**The following changes in the bid documents are effective immediately. This addendum will form part of the contract documents.**

project / projet  
**ADDENDA A1  
 DID LAB  
 RENOVATION**  
 OTTAWA ONTARIO

## DID LAB RENOVATIONS

1  
A601  
**ELEVATIONS  
DOORS (PARTIAL)**  
SCALE 1:20

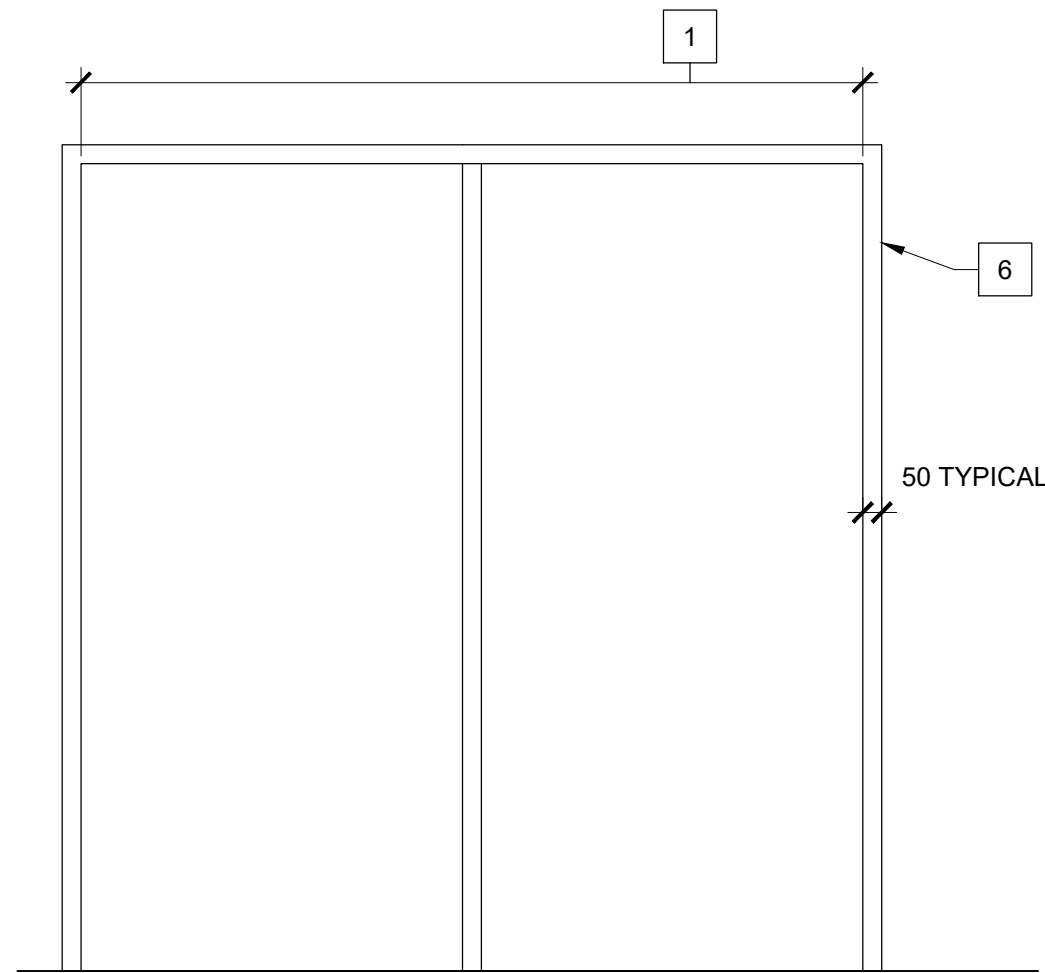
**DELETE** DOOR TYPE C, NARROW LIGHT elevation and **REPLACE** with elevation as indicated on sketch ADD1 – SKA1.
3. Refer to detail 2/A601 ELEVATIONS DOOR FRAMES:

**ADD** FRAME TYPE 2 as indicated on sketch ADD1 – SKA1.
4. Refer to DRAWING NOTES, A601:

1
A121
**3RD FLOOR  
CONSTRUCTION / FINISH PLAN (PARTIAL)**  
 SCALE 1:100

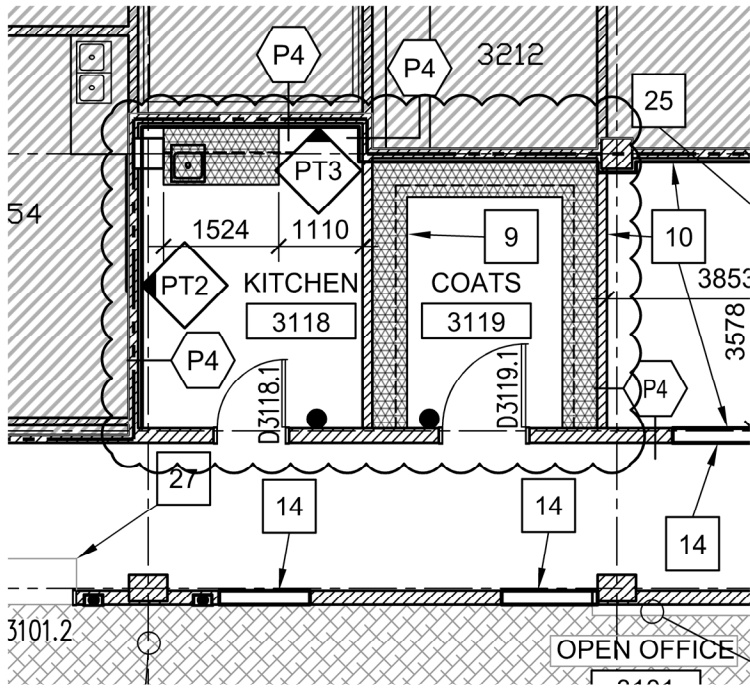
5. Refer to detail 1/A121 3RD FLOOR CONSTRUCTION / FINISH PLAN:

**DELETE** portion of drawing between gridlines 4, 5, J, and H, and **REPLACE** with same portion indicated on ADD1-SKA2.

**ADD** legend item NEW ARCHITECTURAL WOODWORK as indicated on ADD1-SKA2.

NEW ARCHITECTURAL WOODWORK TO BE PROVIDED IN CONTRACT. REFER TO SPECIFICATION SECTION 06 40 00.

Drawing no. ADD1-SKM1 No. du dessin

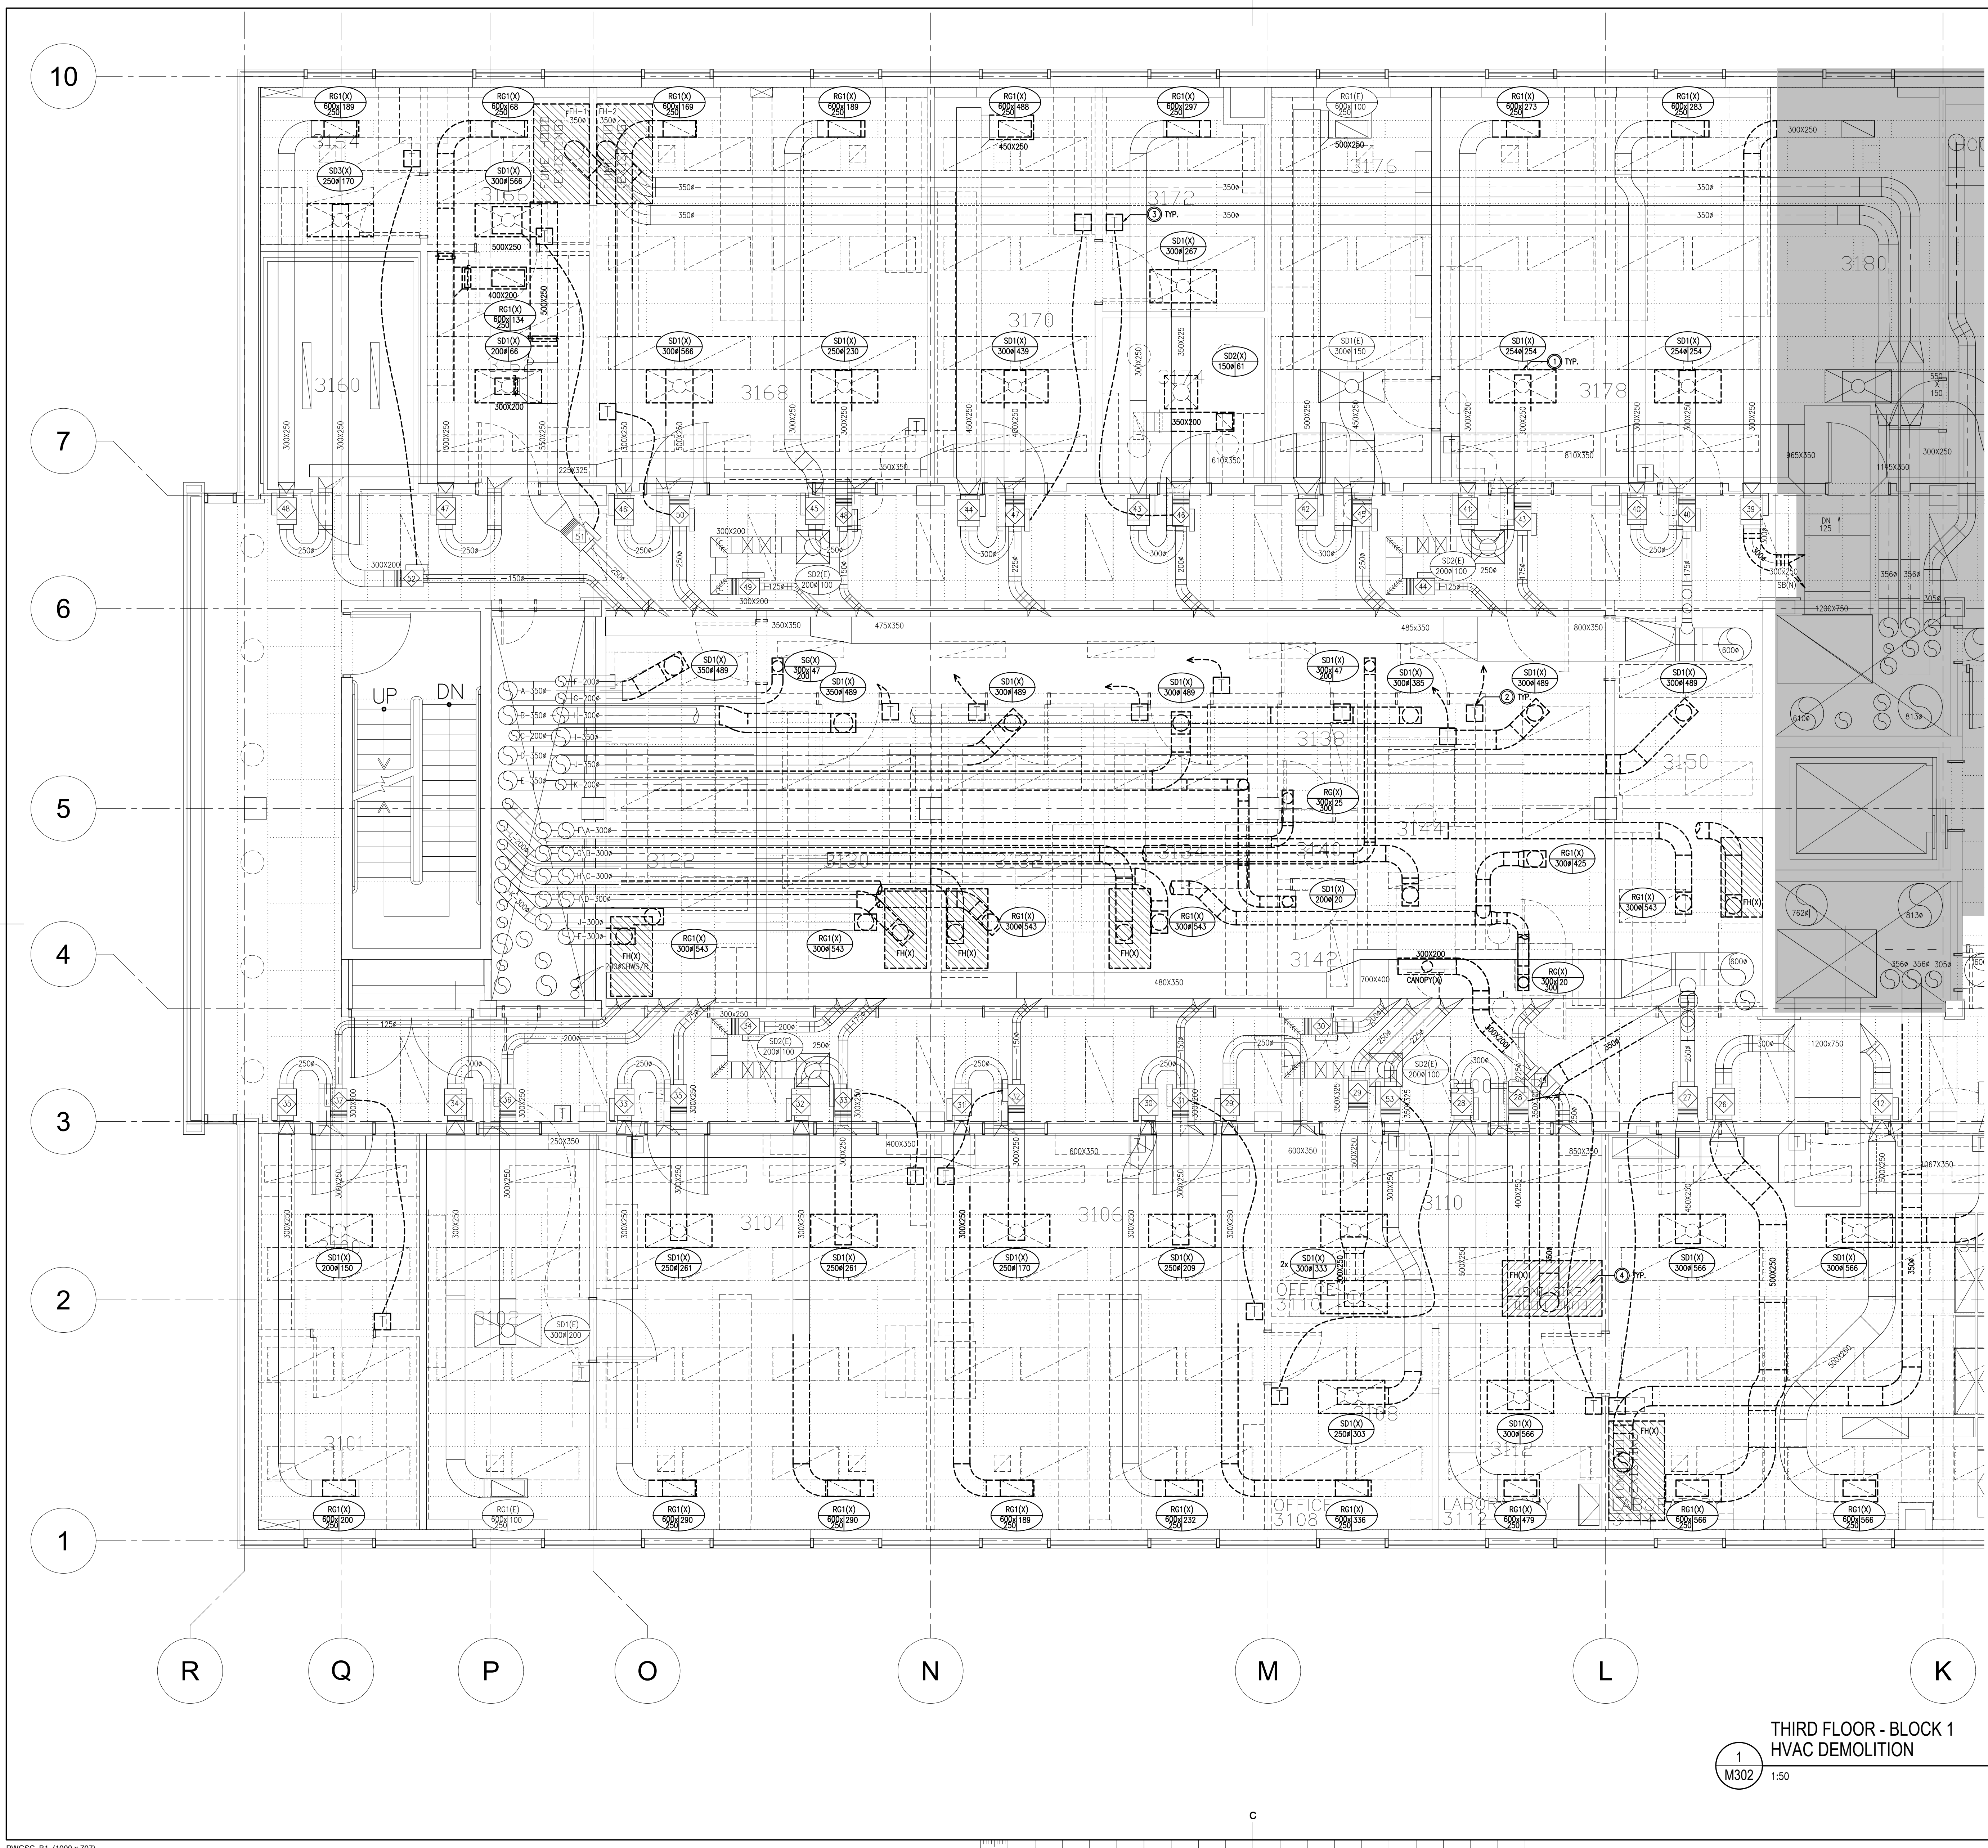
- .1 Add airflow schedule, refer to sketch ADD1-SKM1.
- .2 Add M307 to Drawing List, refer to attached sketch ADD1-SKM1.

1  
ADD1-SKE1 1:100

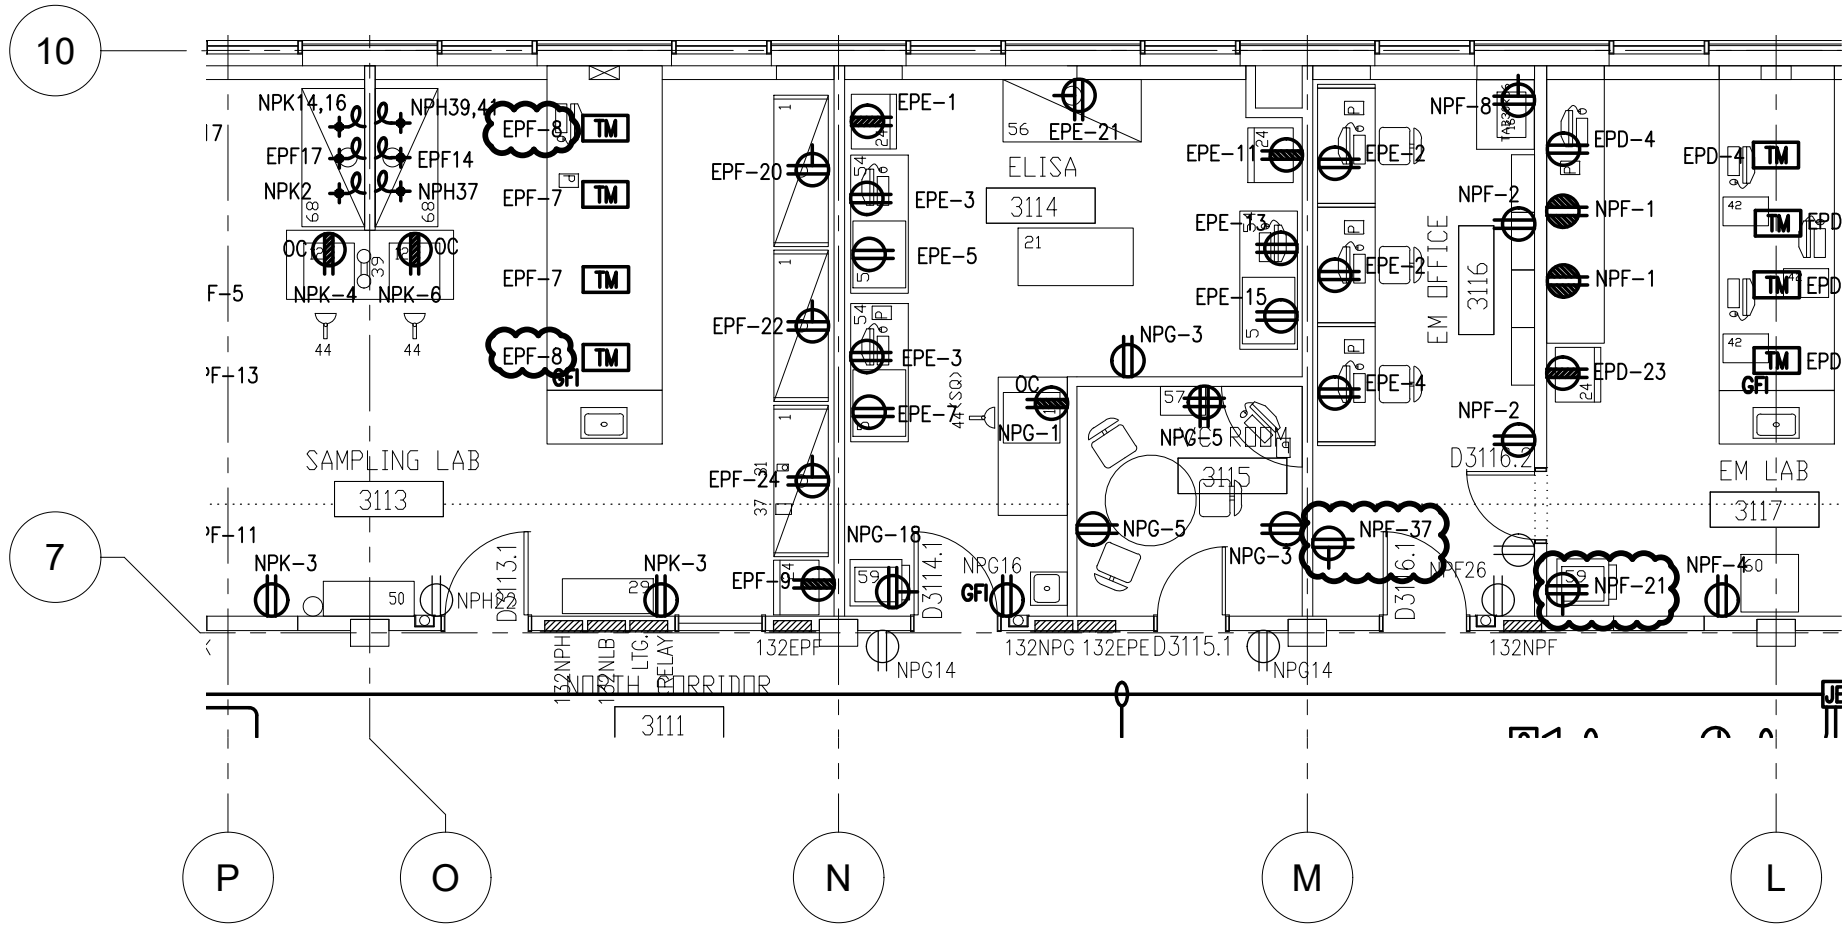
- .1 **DELETE** portion of plan 1/E4 in the area bounded by gridlines 3, 7, J and O and  
**REPLACE** with same portions indicated on sketch ADD1-SKE1.

1  
ADD1-SKE2

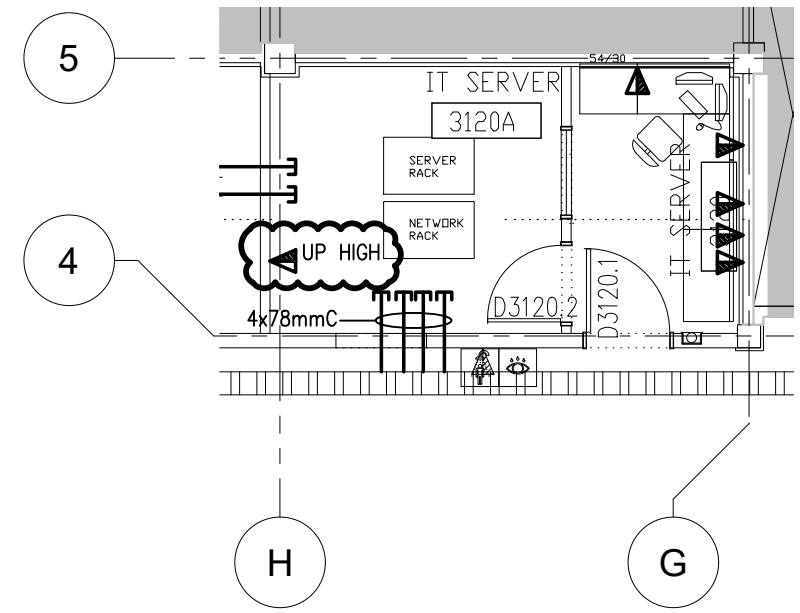
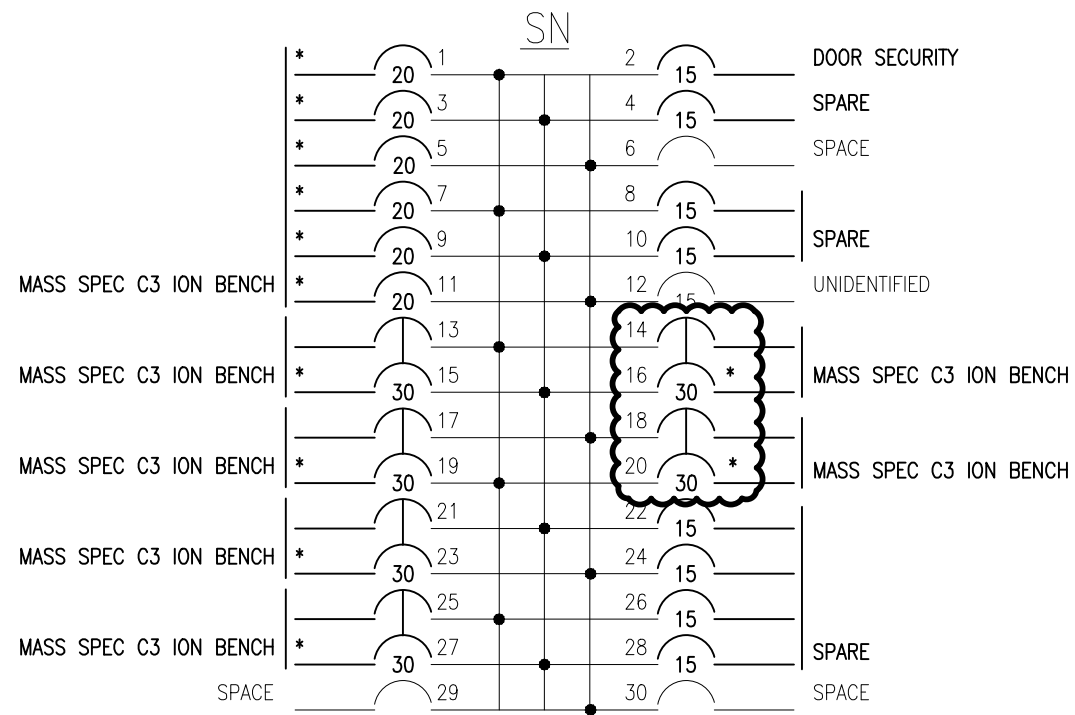
- .1 **DELETE** portions of plan 1/E5 in the area bounded by gridlines 7, 10, L and O and  
**REPLACE** with same portions indicated on sketch ADD1-SKE2.

- .1 **DELETE** portions of plan 1/E6 in the area in the area of gridlines 4H and  
**REPLACE** with same portions indicated on sketch ADD1-SKE2.

- .1 **DELETE** portion of ‘POWER & SYSTEMS LEGEND’ and  
**REPLACE** with same portion indicated on sketch ADD1-SKE2.

Date JANUARY 2019 ADD1-SKE3  
 Date

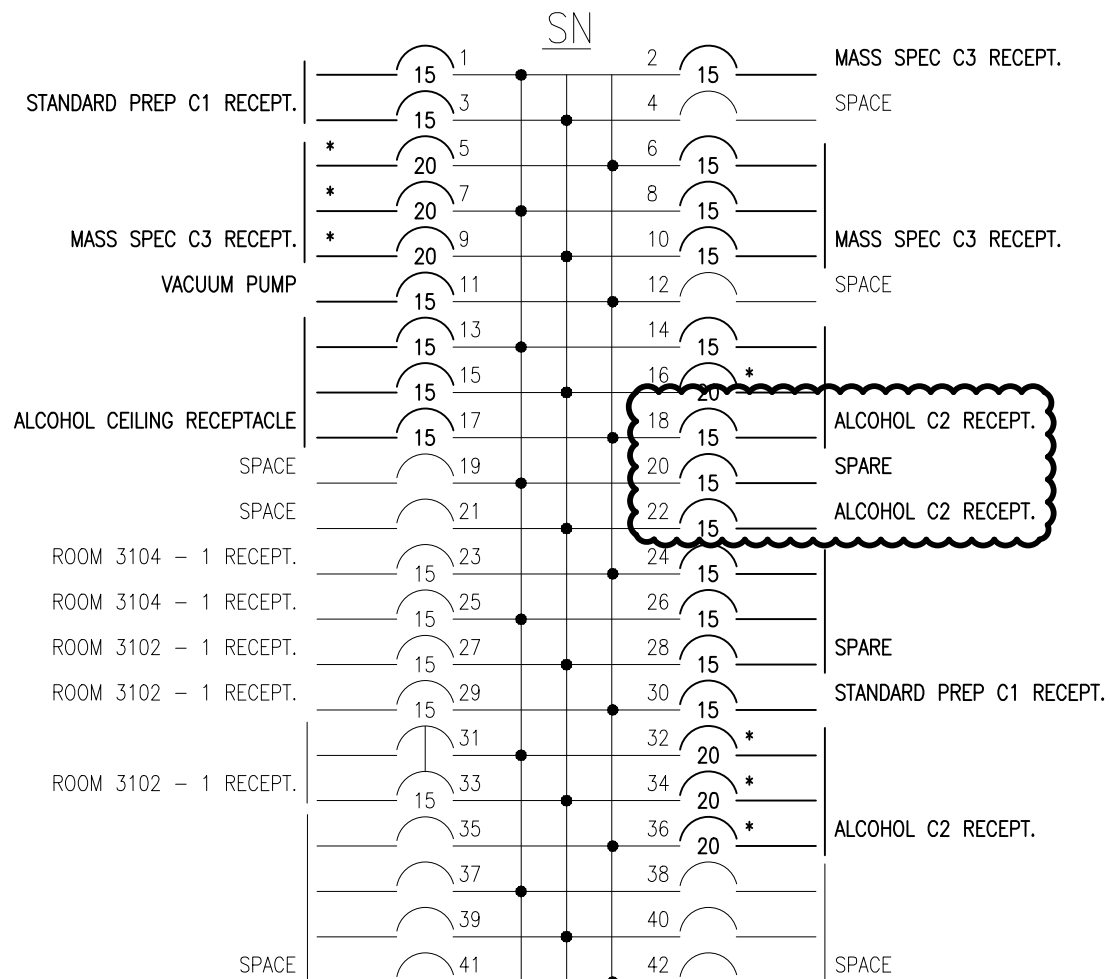
- .1 **DELETE** panel schedules for panels ‘132EPB’ and ‘132EPA and  
**REPLACE** with same panel schedules indicated on sketch ADD1-SKE3.
